# BULLETIN

<b>DATE:</b>	<b>January 3, 1994</b>	<b># of Pages: 2</b>
<b>REFERENCE:</b>	<b>SERVICE BULLETIN # PFISB: 9401</b>	
<b>SUBJECT:</b>	<b>SWIFT PLUS RESERVES with SPECTRA LINES must be inspected for possible faulty bartacks</b>	
<b>STATUS:</b>	<b>This inspection is MANDATORY at the next repack/re-inspection or within 150 days of the issue date of this notice, whichever comes first</b>

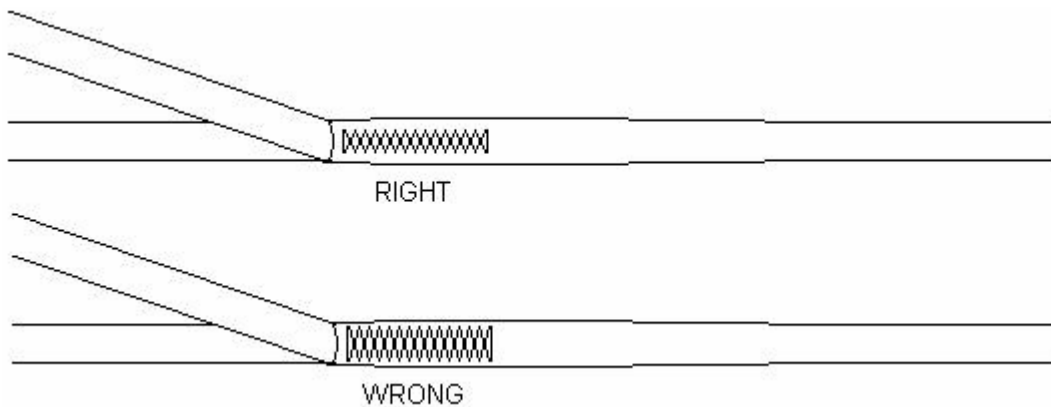
A Swift Plus 225 reserve, serial # R7-2218, manufactured February 19, 1992, was found to have a faulty bartack at the outer D line cascade. The width of the bartack was too wide to catch the finger-trapped insertion of the cascade, allowing the cascade to be pulled free by hand.

On the affected reserve parachute the A and C lines are continuous and the B and C lines are cascaded and fingertrapped into them. Therefore, the failure of this junction is not catastrophic and will not lead to a malfunction.

All bartacks of the suspension line sets must be subjected to a visual inspection and compared to the enclosed drawing. "Good" bartacks will have a centered appearance and ample material on both sides of the stitches.
